Comments on 1772 Church Street Project: Residential Building

Church Street Neighbors and DC Historic Designs, LLC

ANC 2B Zoning Preservation & Development Committee

July 2014

CAS Riegler Project Height Study

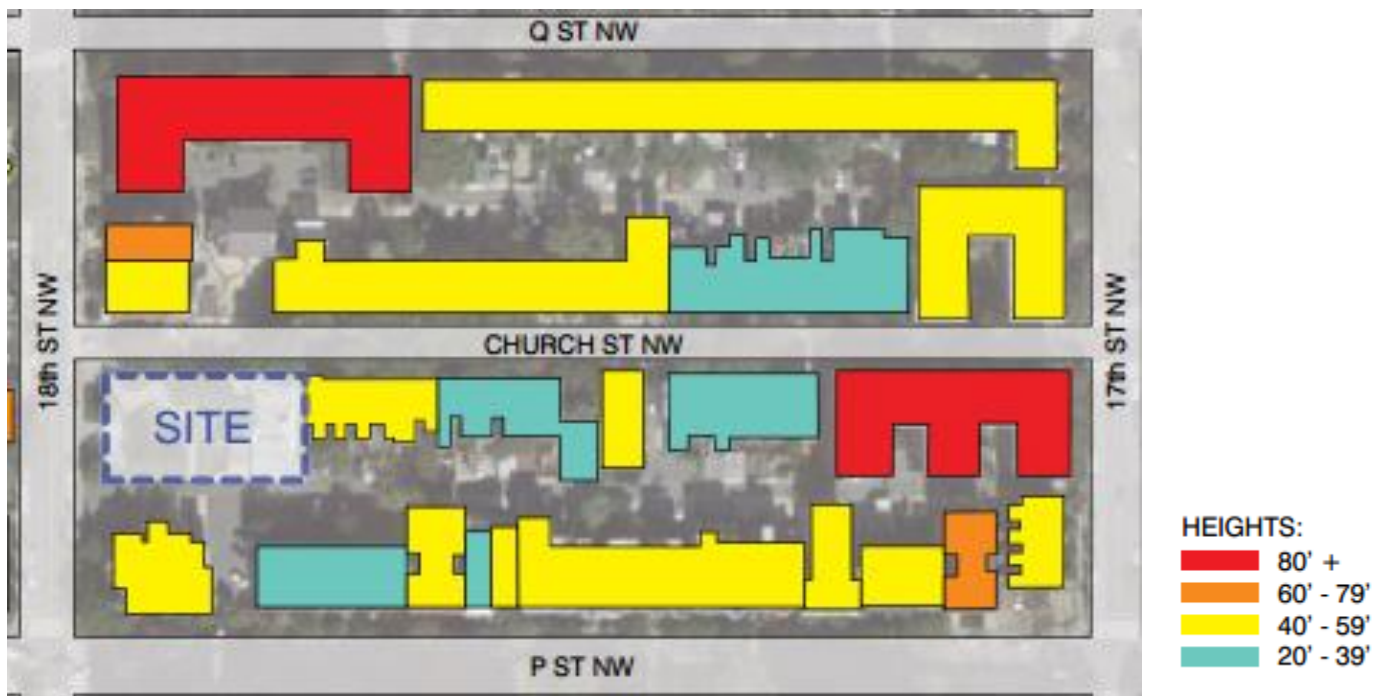
CAS Riegler's height study for the proposed residential building at 1772 Church Street is misleading and cannot be used for justifying both the heights of a new church and a residential building for the same project. The relevant buildings for comparison of a residential building are the immediately adjacent buildings along the interior of the Church Street block, rather than just any of the taller buildings that can be identified throughout the broader neighborhood.

While taller buildings used as comparables in this study may justify the height of the new church, as they are located on the corners of much wider streets, but the buildings cited in the study are inappropriately used as comparables for the residential building located in the interior of the Church Street block between 17th and 18th Street. They exceed the height of the current Parish Hall and the residential buildings on Church Street by as much as 40' and more.

CAS Riegler Project Height Study. Sheet A-4.

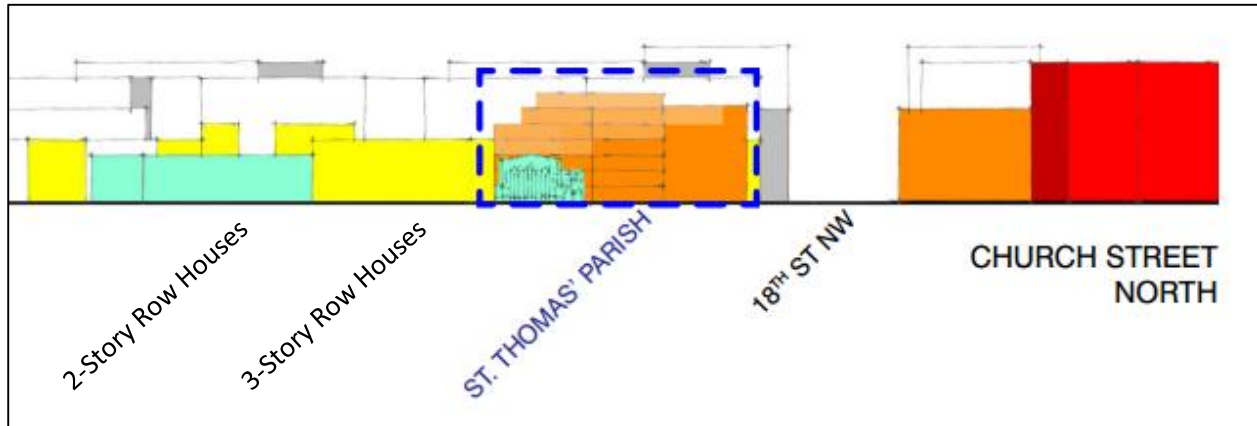
All the 80' + buildings along the north side of the 1700 block of Massachusetts Avenue included in the height study, with the exception of 1785 Massachusetts Avenue, are outside the period of significance for the Dupont Circle Historic District (after 1931). Three of the larger buildings cited on Sheet A-4 (80' +) in the study as context for the large residential building are also outside the period of significance for the Historic District and therefore should not be used as comparables for either the church or the residential building (Numbers 1, 2, and 3 below).

1747 Church Street (#4 below) is depicted out of context with its neighboring buildings and gives the impression of a tall building in the center of the block. It is actually on the same scale as the three-story rowhouses to its immediate west and therefore does not serve as a justification for a taller building.

CAS Riegler Project Height Study. Sheet A-6.

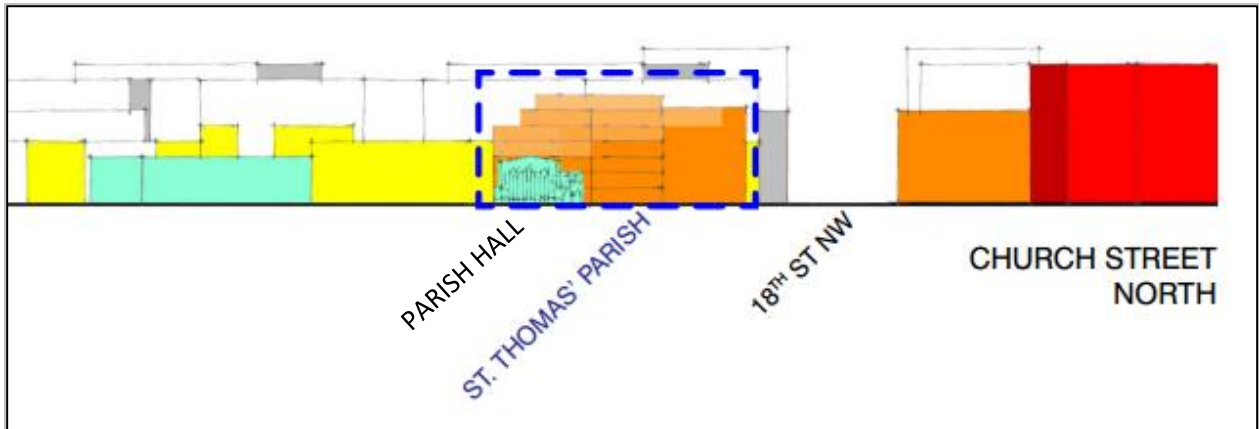
From the example given in CAS Riegler’s own height study, the adverse effects of applying these heights to development on Church Street are clear. The proposed residential building towers over the adjacent 3-story row houses (in yellow below) and in particular over the 2-story row houses (in turquoise below).

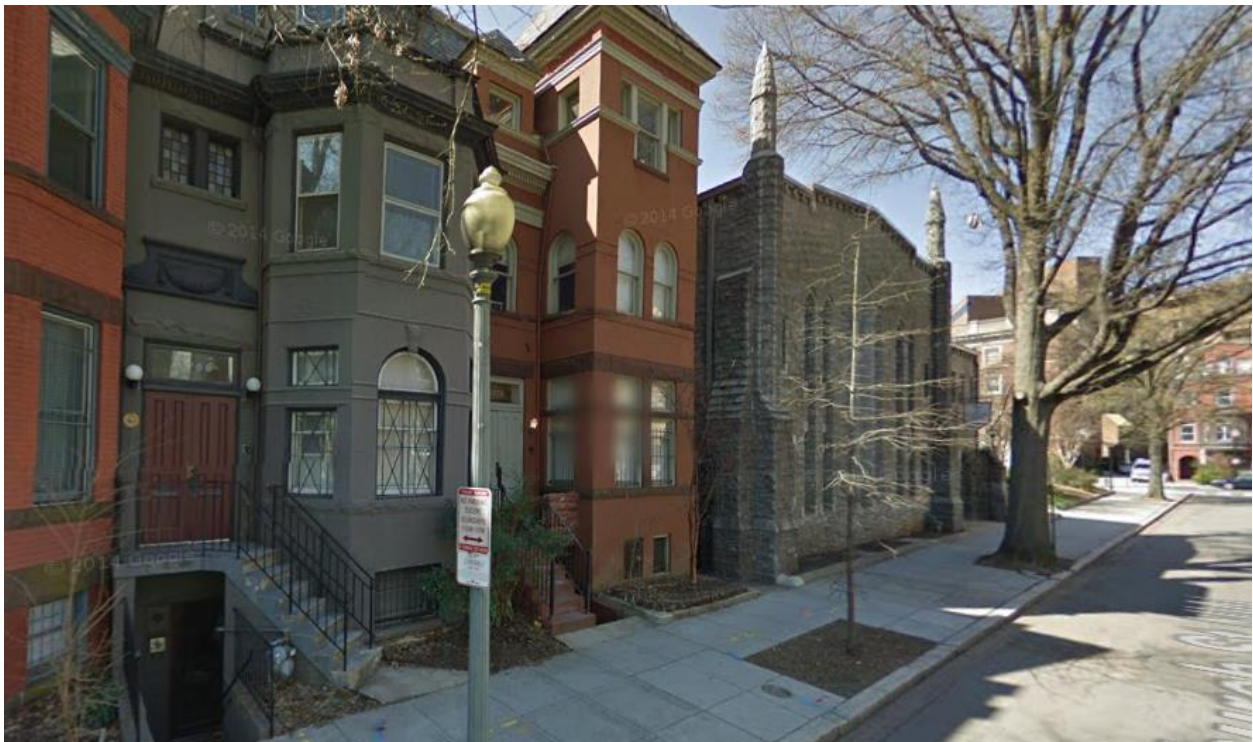
Due to the proposed total height of just under 80 feet (not including any additional necessary mechanical equipment above the penthouse), the residential building will be extremely visible from any perspective,

not only from within the historical context of Church Street itself but from all other view sheds as well. It will loom above any of the other buildings in sight, including the proposed new church itself.
